SUB-COMMITTEE ON SHIP DESIGN AND  
CONSTRUCTION  
1st session  
Agenda item 4

SDC 1/WP.7  
23 January 2014  
Original: ENGLISH

**DEVELOPMENT OF PROVISIONS TO ENSURE THE INTEGRITY AND UNIFORM  
IMPLEMENTATION OF THE 1969 TM CONVENTION****Report of the drafting group****General**

### DRAFT TM.5 CIRCULAR

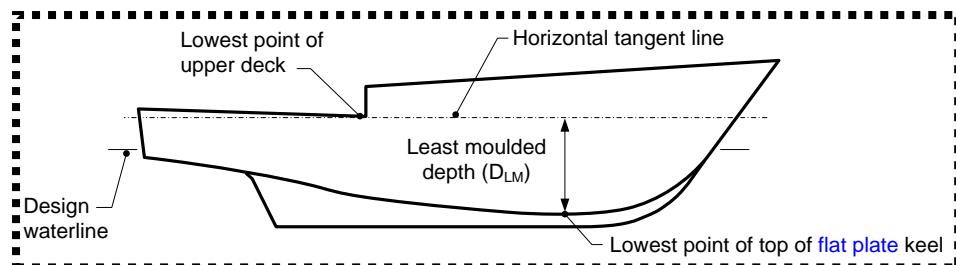
- .1 Length of Unusual Hull Configurations (A.2(8)-2 Fig) The group agreed to changes to the figure to remove the illustrations for submersibles and dockships, in response to concerns over the similarity of these hull shapes to conventional hull forms. The remaining illustration of the column-stabilized unit was included in the draft TM.5 circular.
- .2 Spaces within Awning Boundaries (R.2(4)-2) The group agreed that this draft revised interpretation required further development, to address lack of agreement on whether the awning orientation (i.e. horizontal or vertical) should be taken into consideration. In addition, concerns were expressed regarding

- A.2(8)-1 When a ship does not have a rudder stock, the length should be taken as 96% of the total length on a waterline at 85% of the least moulded depth measured as defined in regulation 2(2).
- A.2(8)-2 The 96% overall length should be used for ships that do not have a clearly defined stem or stern, such as column-stabilized units, submersibles, floating docks, and similar ships.

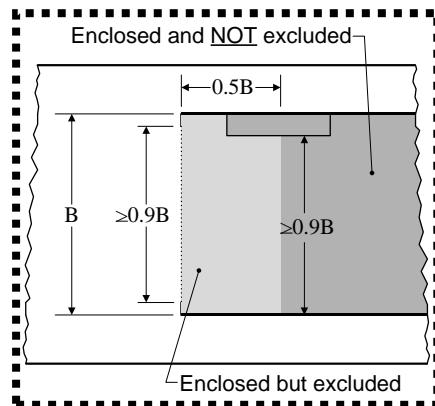
- .6 Deck Breadth and End Openings (R.2(5)-6 Fig) The group agreed to retain only the plan view illustration of the figure, with changes to show the sides of the ship. The group concluded that the isometric and sectional views were inconsistent in their representation of "A Section" and that, subject to the changes described above, the additional views were not needed. The amended plan view illustration was included in the draft TM.5 circular.

- R.2(5)-6 When applying the provisions of regulation 2(5), the phrase "breadth of the deck" means the breadth of the deckhouse structure at the line of the opening of the space, regardless of whether or not the structure extends from side to side. In addition to erections extending from side to side, the requirements for excluded spaces under regulation 2(5) are also applicable to structures that do not extend from side to side of the ship. In such structures B means breadth of a structure that does not extend from side to side, measured in way of the opening (see appendix 1 to the Convention).

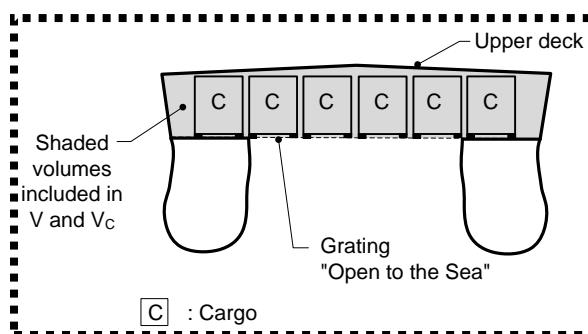
- .8 Deck Structure Heights and Side Openings (R.2(5)(c)-1 Fig) The figure was not included in the draft TM.5 circular (see paragraph 7.7).
- .9 Cargo and Buoyant Spaces Open to the Sea (R.6(3)-3 Fig) Some delegations expressed concerns over whether enclosed spaces depicted in the top two illustrations could also be construed as cargo spaces. The group agreed that the remaining illustration was relevant and it has been revised to maintain the consistency with other figures in the draft TM.5 circular that use shading to indicate enclosed spaces. The amended figure was included in the draft TM.5 circular.

- R.6(3)-3 Spaces open to the sea should not be excluded from the total volume of all enclosed spaces ( $V$ ) if they are used for cargo and/or buoyancy purposes.

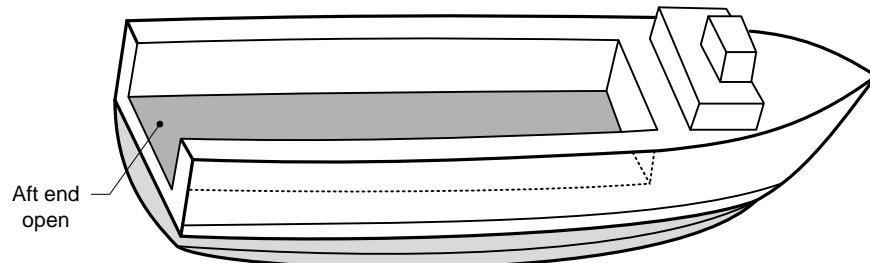
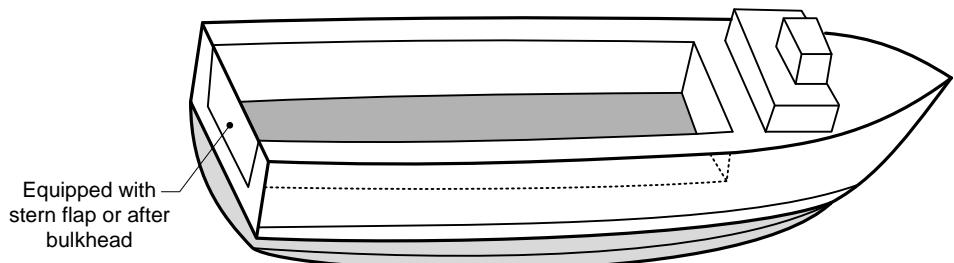
- .10 Correction to Dockship Figure (N.2(1) Fig) The group agreed to changes to the figure to maintain the consistency with other figures in the draft TM.5 circular that use shading to indicate enclosed spaces, and to include associated labelling. The amended figure was included in the draft TM.5 circular.
